RM190790 Integrity Care Group - Olive Estate Response to RFI

This is a response to your request for further information (RFI) dated 6 August 2019, on the above application for resource consent.

Attachment 1 – Canopy plan of catchment areas
Attachment 2 – V&P Storm Water Run Off Calculations
Attachment 3 – TCEL Olive pond capacity dated 2/10/2019

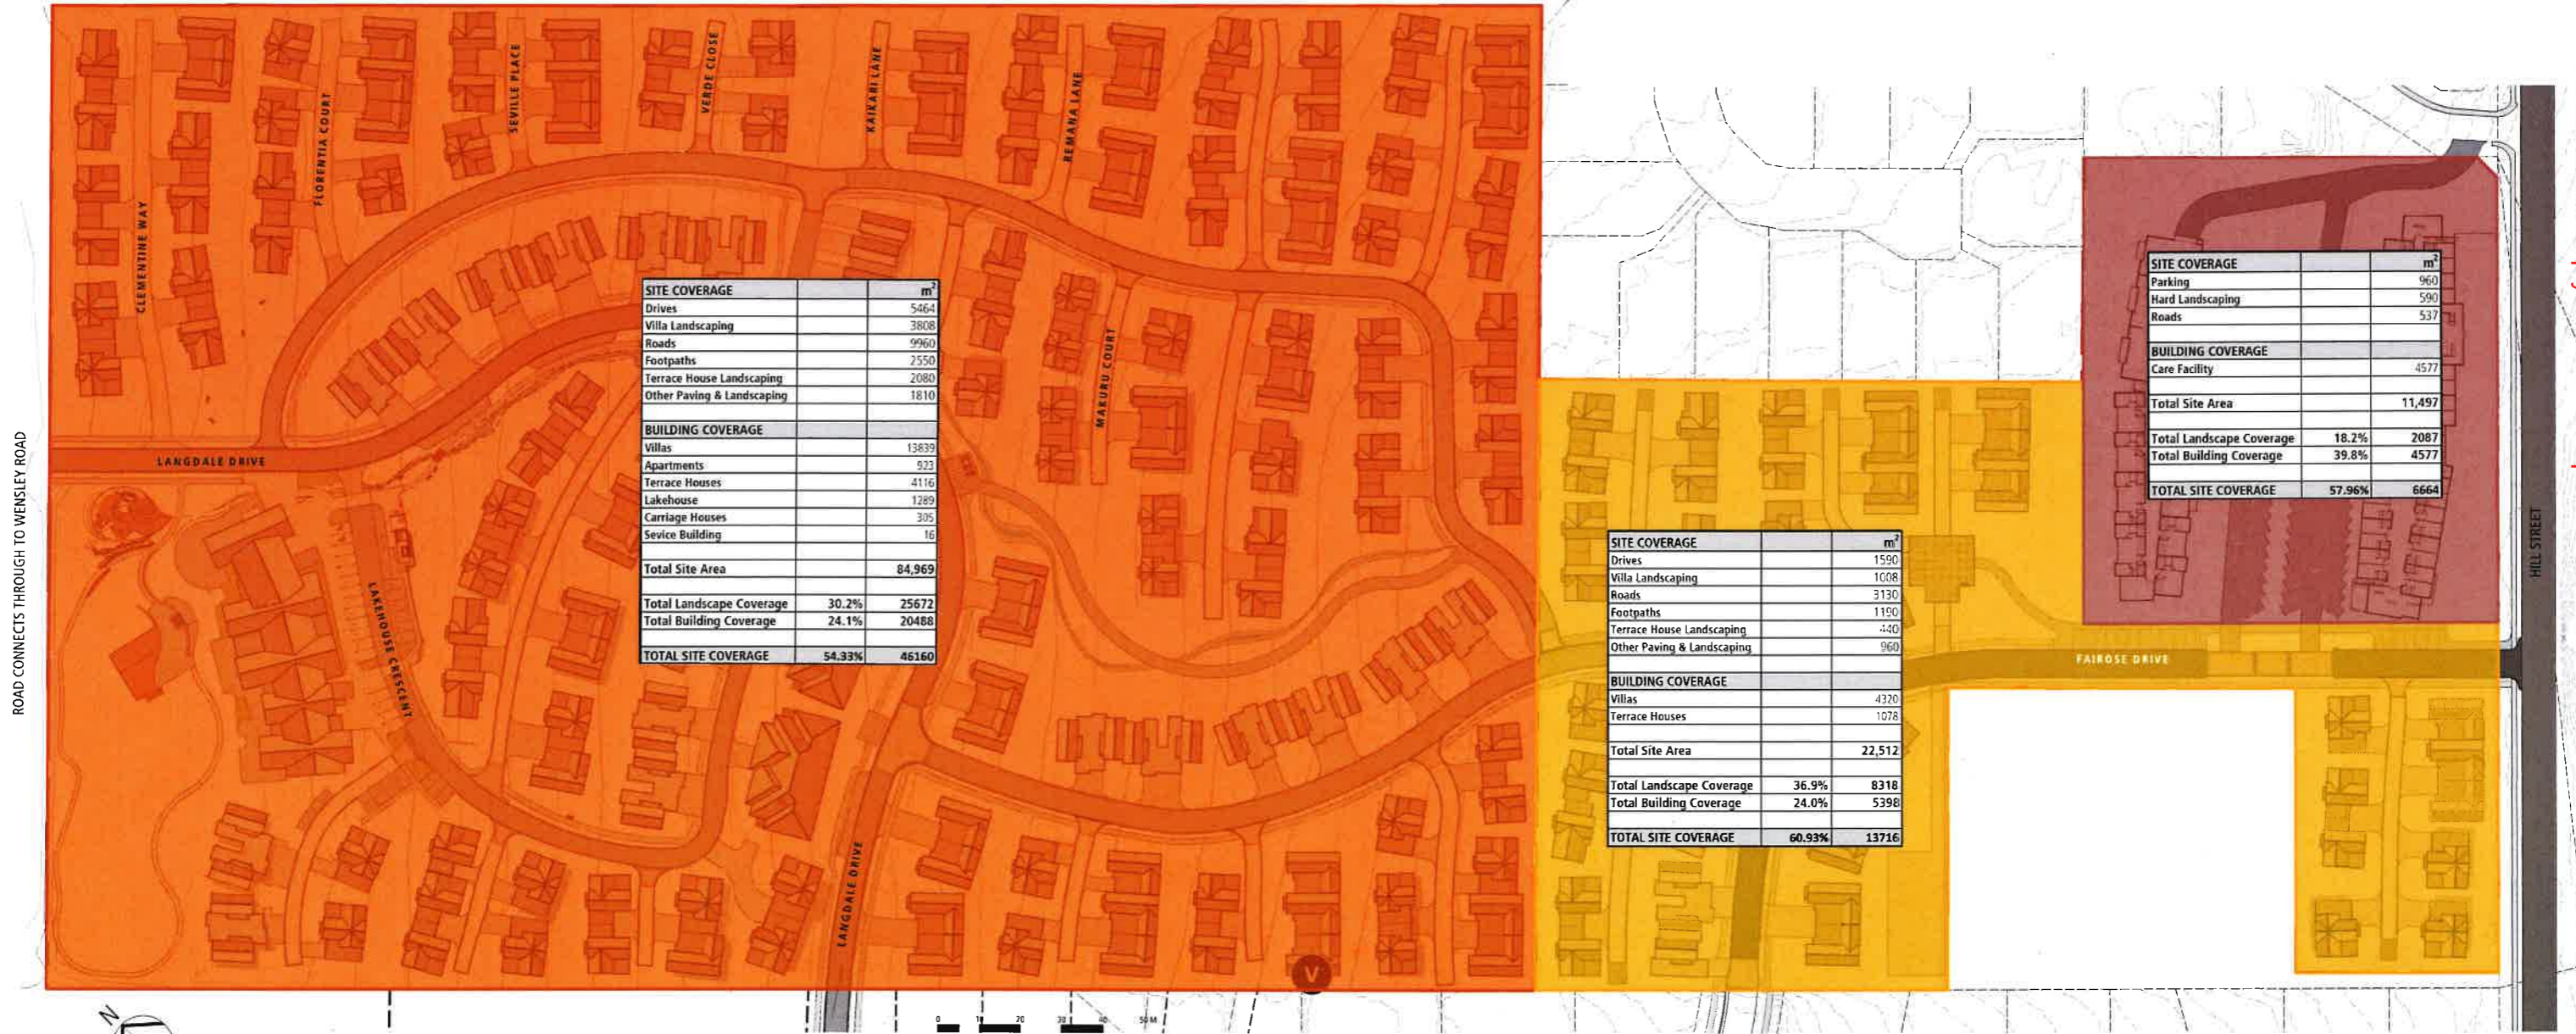
Please provide a peer review of the storm water for the Olive estate from an appropriately qualified and experienced engineer. There is very limited information provided as part of the application and the information which has been provided is based on the initial report undertaken prior to construction of the first stage of development.

Envirolink provide a report dated 2013 submitted as part of RM 13034V1. The Council is concerned that the run-off coefficient used in this report is lower than the coefficient used in more recent storm water reports in this area.

The first point to make is that aerial photos can be deceptive in assessing coverage. Accordingly Canopy have undertaken measurements and calculations for the actual coverage areas of hard standing, roofs, hard and soft landscaping over not only over the proposed development but also over the existing consented Olive Estates site (please refer Attachment 1 Canopy plan of areas). From these areas; runoff coefficients have been calculated by us and storm water flows verified and tabulated (please refer to attachment 2 for our separate report on storm water flows). Our storm water report figures have been peer reviewed by TCEL and accordingly TCEL also reviewed their original pond report and confirmed that all storm water from the proposed development can be drained using a combination of the 300mm pipe to Wilkinson Pl, the 600 pipe in Fairose Dr or the future connection via the existing Olive Estate site (please refer to Attachment 3 for TCEL pond report dated 2/10/2019).

In passing the figures derived in our appended storm water calculations agree reasonably well with the Envirolink Report of April 2013 (submitted as part of the engineering report already) once allowance was made for more of the subject land having to drain via the existing main Olive Estate block pond than originally anticipated but that is primarily due to the restriction on the Wilkinson Place pipe line of only pre developed flows at Councils bequest. On the main Olive Estate site the 2013 Envirolink Report had a runoff coefficient of 0.60 and by including hard landscaping that figure is now 0.609 for the existing development and so this represents only a very minor change.
